**RE: Belhaven Hotel | Application No. 1221-05
2 Rehoboth Avenue, 5-14 Wilmington Avenue & 10-12 Baltimore Avenue
Tax Map Nos. 334-14.18-20.00, 21.00 & 35.00, 334-14.14-55.00
Rehoboth Parcel Nos. 4633, 4645, 1417 (hotel) & 645 (parking)
C-1 Central Commercial Zoning District
Site Plan Review (2nd Review)**

In response to your letters, representatives from Wallace Montgomery (WM) and I reviewed the Site Plan Application and related plans for the above-referenced project for John N. Papajohn (Applicant).

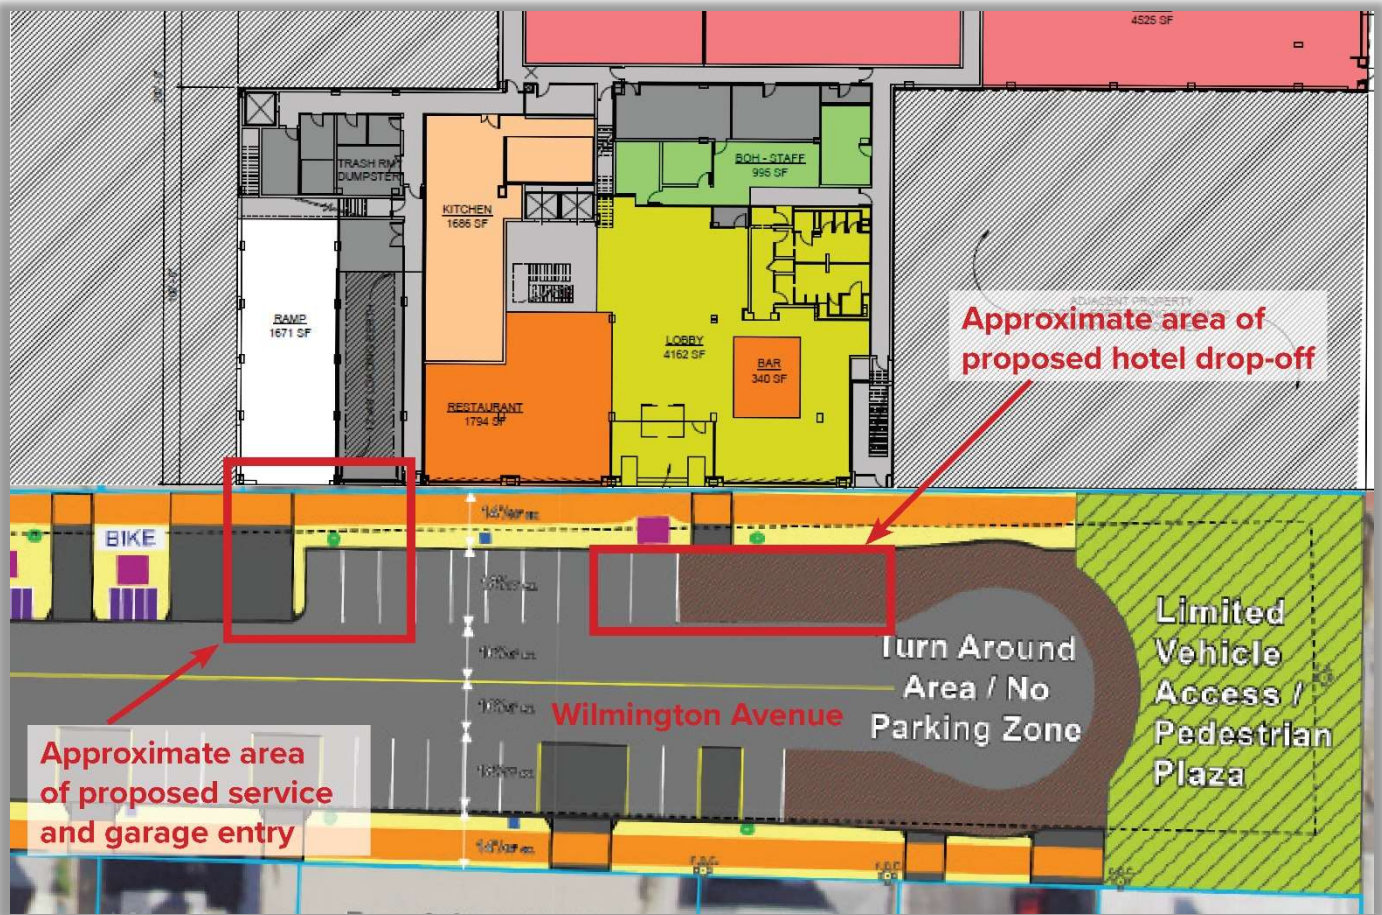
The sketch below (not to scale) shows a portion of the proposed development ground floor fronting Wilmington Avenue, along with the streetscape concept for that section from the final Baltimore and Wilmington Avenue Streetscape Concept study. Although the streetscape study remains in a concept form, it is worth comparing the two concept proposals. The Belhaven site plan calls for a portion of the streetscape (approximately 45 ft.) to be reserved for the service and garage entry and another area to be reserved for a proposed hotel drop off (highlighted by red outlines).

The proposed garage and service area entryways will result in the loss of approximately 3 or more on-street parking spaces. In addition, the area would result in vehicles crossing an area designed to promote pedestrian circulation. Special design consideration should be applied to ensure the vehicle access area does not inhibit the goal to promote pedestrian transit. The area for the proposed hotel drop-off is directly adjacent to the proposed turn-around area, an area that is also used for local business deliveries. It would also result in the loss of approximately 2 or more on-street parking spaces.

To address the site design and access objectives, outlined in the CDP and streetscape concepts, the proposed plan should incorporate techniques to maintain the pedestrian scale and prominence of the pedestrian circulation path across this frontage. Techniques that should be considered and incorporated include:

- The loading area service entry opening should contain a door that is designed to mimic the adjacent store window panels when closed. This could include glass panels that are glazed to

screen the opening while maintaining the repetition of the public space openings. Another possible solution would be to pick up design aspects to use in this location to lessen its appearance as a loading area/service entry.

- To address vehicle access across the pedestrian circulation path:
 - Ensure the pedestrian access route is at least 5 ft. wide (preferably 7 ft. wide)

- maintain the surface treatments along the pedestrian access route
 - ensure the slope of the surface across the pedestrian access route is maintained and level

- change driveway material at the building line to demarcate the transition to the pedestrian circulation path
 - all driveways must meet ADA accessibility requirements

- curb returns for driveways are prohibited because they create tripping hazards
 - driveways should be at least 10' deep past the right of-way line, so that standing vehicles do not encroach onto the sidewalk

- Signs, mirrors, flashing lights, or other warning signals may be needed at garage exits where they cross the sidewalk. It should always be clear that vehicles must yield to pedestrians on the sidewalk. Stop signs should be used where sight distance is restricted.

The Applicant should clarify how their proposed plan can best incorporate the proposed streetscape improvements designed to revitalize and improve the Wilmington Avenue corridor.
